Technical Service Information

THM 440-T4 BOTTOM PAN OIL FILTER CHANGES

Figure 1

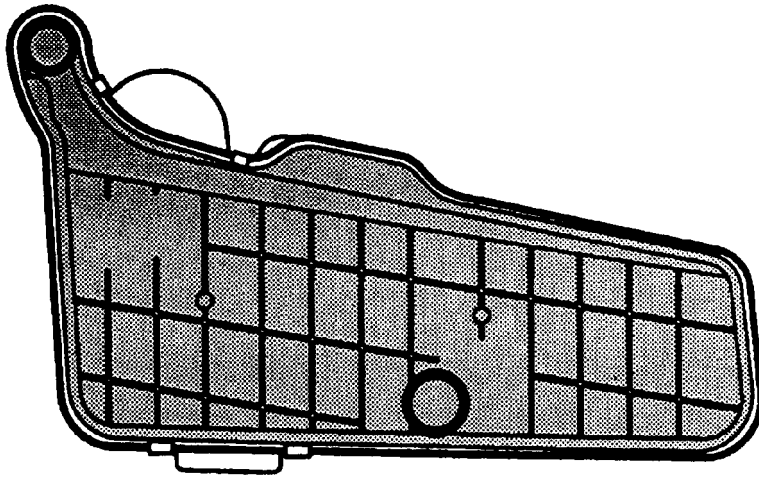
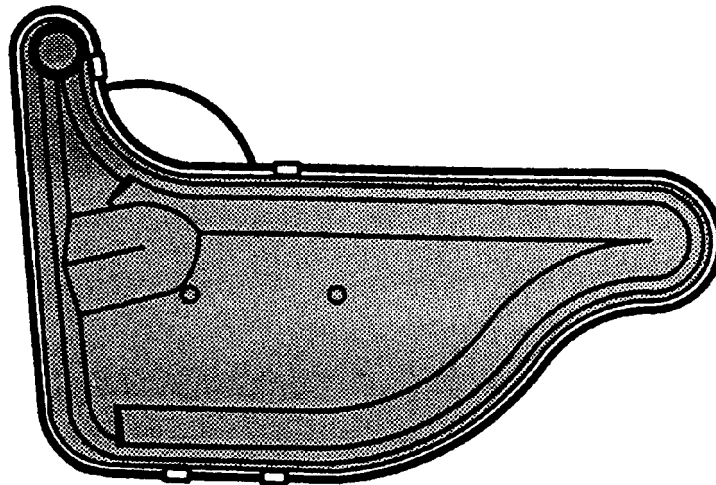
CHANGE: Beginning at the Start Of Production for the 1993 model year, THM 4T60 (440-T4) transaxle bottom pan oil filters were revised in appearance.

(1) BOTTOM PAN OIL FILTER - Upgraded to the "Sealed Seam" design level and can easily be identified from the previous filter, as shown in Figure 1. The new design level made the THM 4T60 transaxle oil filter very similar in appearance to the THM 4T60-E transaxle oil filter, but they have different baffles, as shown in Figure 2.

(1) New design and previous design level THM 4T60 (440-T4) transaxle bottom pan oil filters can be used on any THM 4T60 (440-T4) transaxle as shown in Figure 1.

Figure 2

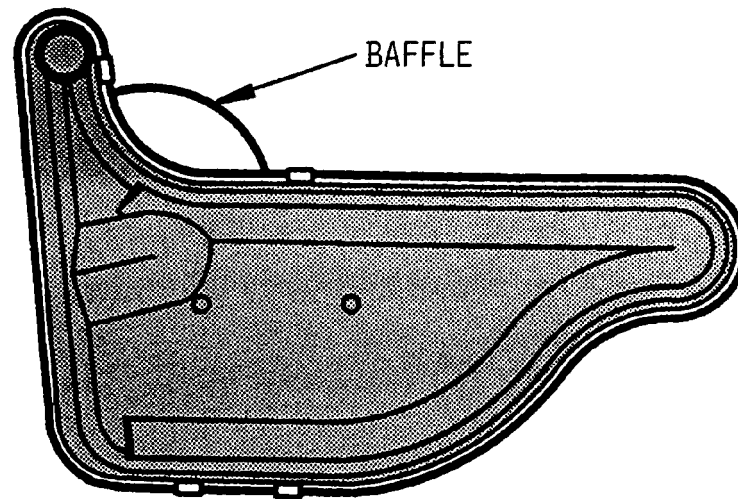
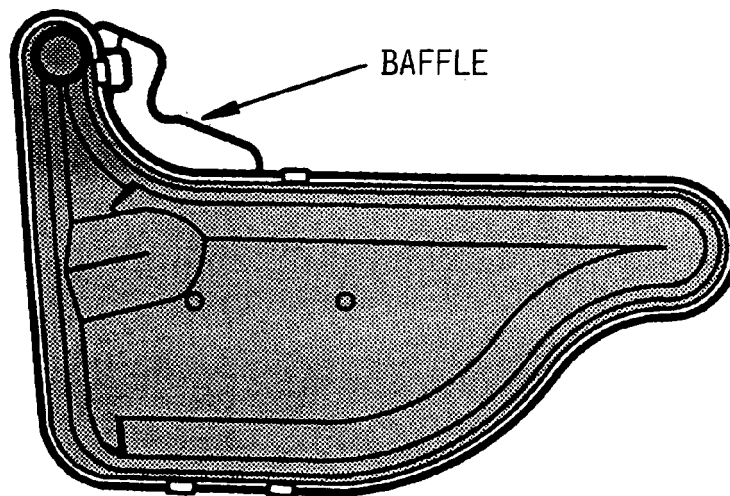
(2) THM 4T60 (440-T4) and THM 4T60-E transaxle bottom pan oil filters, ARE NOT INTERCHANGEABLE, because of the different baffles as shown in Figure 2. Regardless of which way they are mixed, the baffle will interfere with the accumulator housing.

THM 4T60 AND 4T60-E TRANSAXLE OIL FILTERS WILL NOT INTERCHANGE!
